**LINCOLN CITY/LANCASTER COUNTY PLANNING STAFF REPORT**

**for January 26, 2006 CAPITOL ENVIRONS COMMISSION MEETING**

**PROJECT #:** Change of Zone #05082

**PROPOSAL:** Change from R-6 Residential District to B-3 Commercial District

**HILLHOUSE**  
 SCALE 1" = 40'

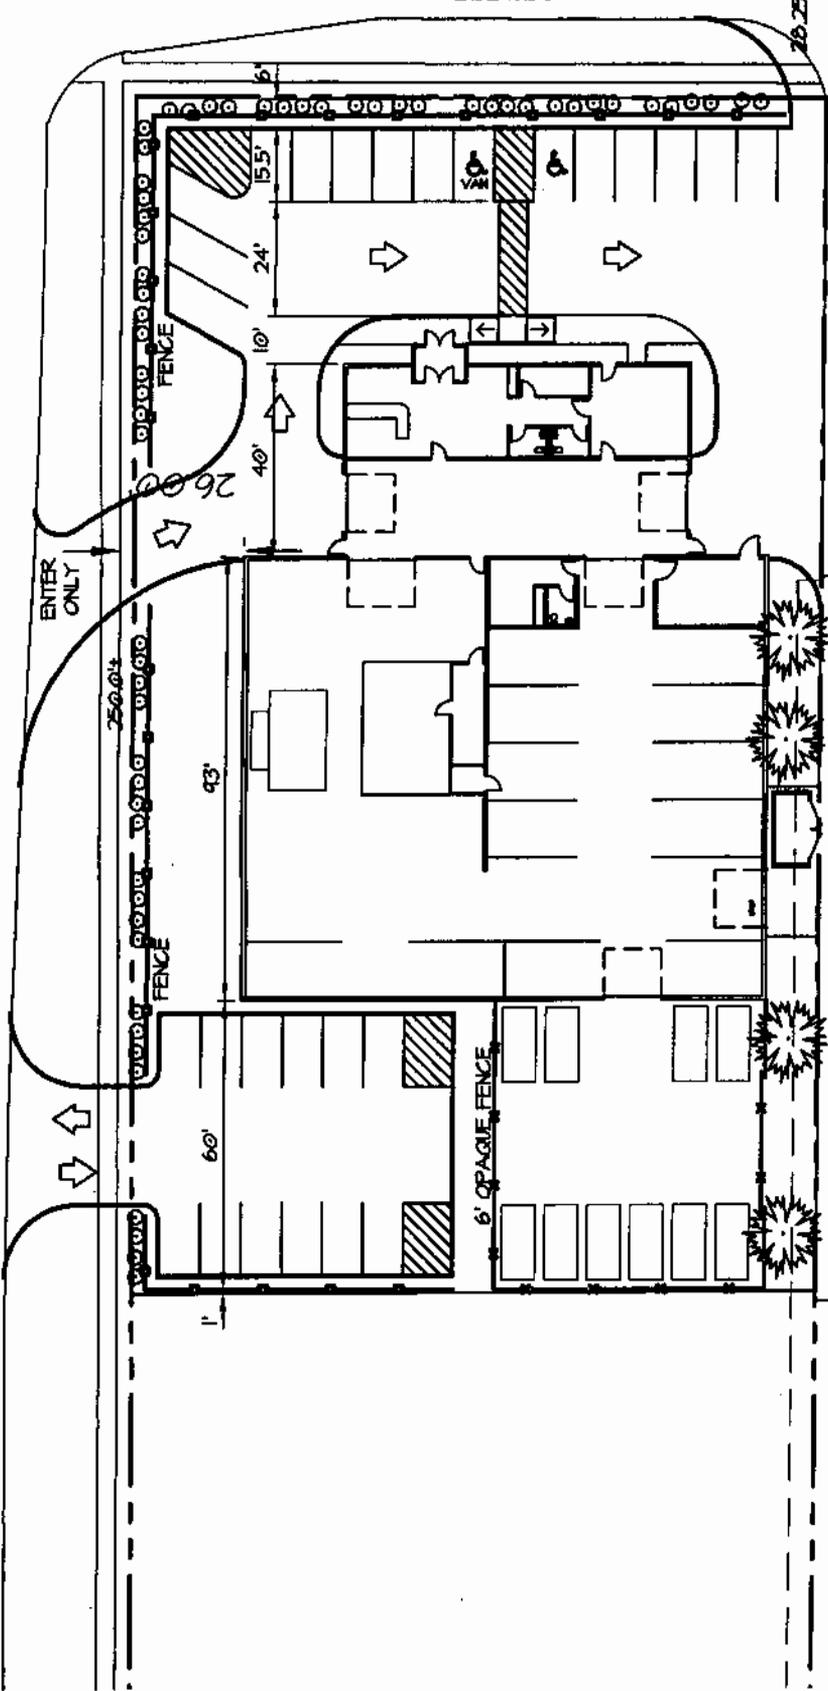
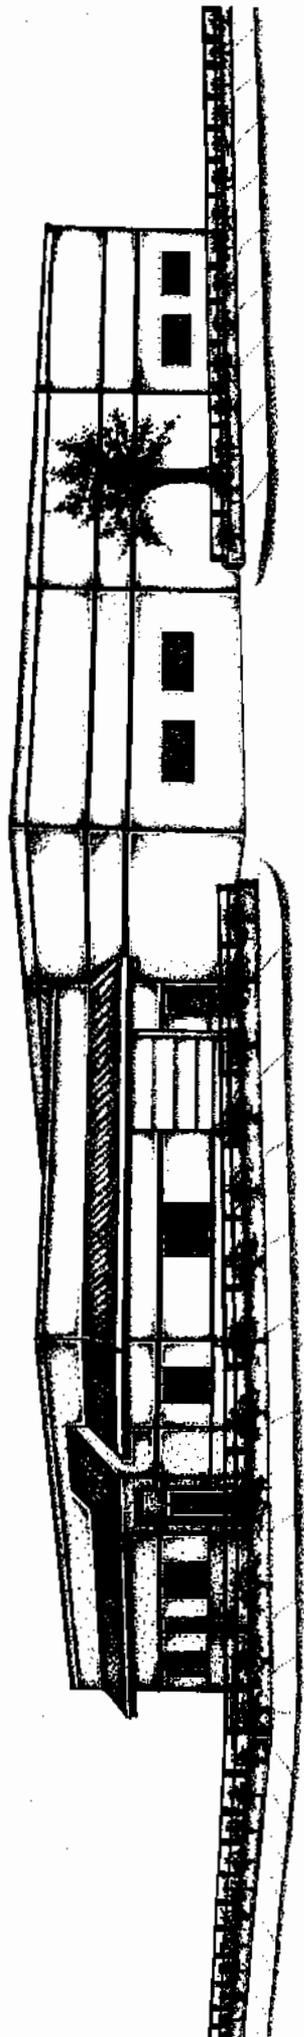
7. Public Works - Development Services comments:
  - 7.1 The site plan that is attached to this request for a change of zone from R-6 to B-3 raises several questions and Public Works has concerns with the location of the zone change abutting a quite populated residential area to the south of this proposed business zoning.

- 7.2 The access to this property if approved will have to be from the alley south off of 21st Street. No access from "K" Street will be considered. Public Works assumes that this will be an important issue regarding this proposed change of zone request.

Hillhouse then provided a drawing of the proposed building. He stated that the building is quite beautiful. One of the biggest problems with auto repair shops is the appearance of overhead doors. He has limited the amount of doors on the K Street side. The incoming and exiting of the vehicles will be to the rear in the alley. They will not be backing out onto K Street at all. The building is a single-story stucco building with sufficient landscaping. He feels it would enhance the area.

Searcy commended Hillhouse on the aesthetic appearance of the building. He then asked about the process. Zimmer stated that the change of zone will go to Planning Commission and then City Council. If this is approved, the design standards and site layout would come to the Capitol Environs Commission for a Certificate of Appropriateness.
